MUNICIPAL OFFICE,

BUILDING SURVEYOR'S REPORT.

NOTICE UNDER SECTION 96 OF ACT III OF 1901.

I beg to inform you that I intend building additions
alterations on plot No. 75 & 54
Survey Sheet No. A-26 situate in Chuha
Street, Napier Quarter.

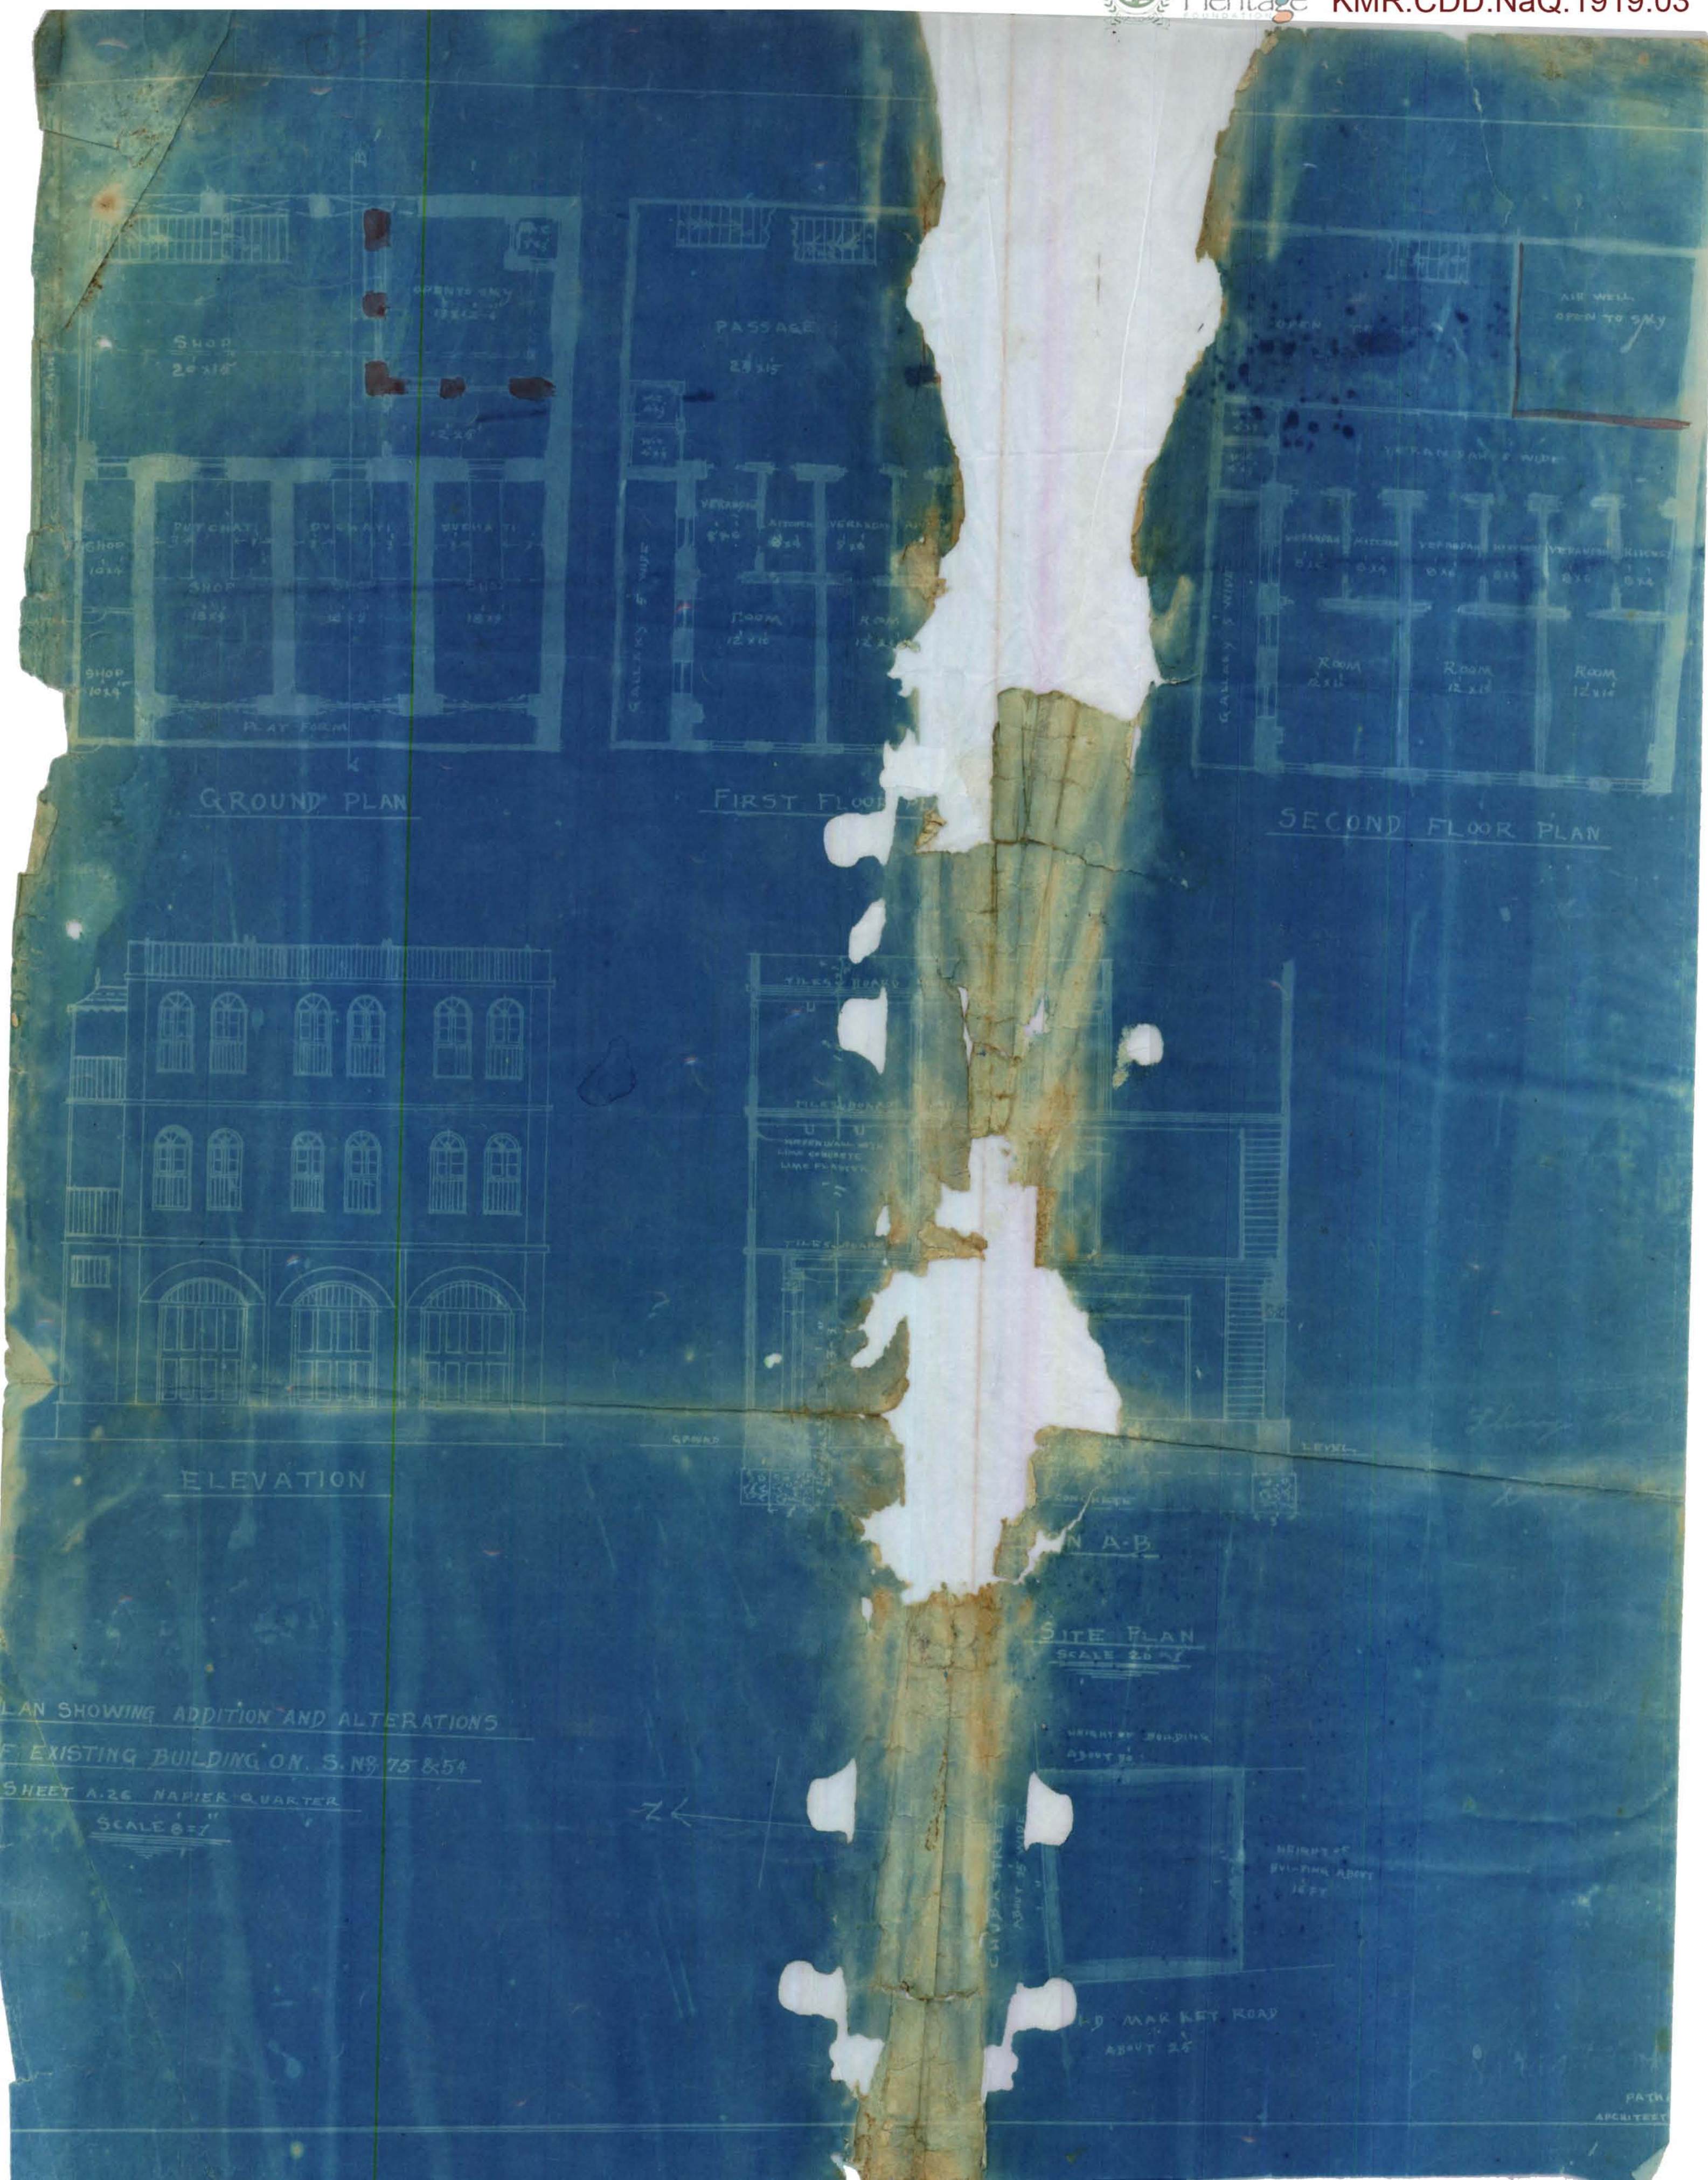
Building Surveyor's Report Sir with respect to this I beg
to report that the proposed addition
will make the first two shops in the N.E.
Corner of the plot devoid of ventilation
+ will make the bldg insalutary

Remarks Sir, with reference to this I beg to report
that the applicant proposes to do away with the vegetable market & provide
a shop which the adjoining shops + upper rooms
will be devoid of light + air. Request your order

The proposal to convert the present air well
into shops cannot be permitted. The
plan is disapproved.

Ventilation must be provided
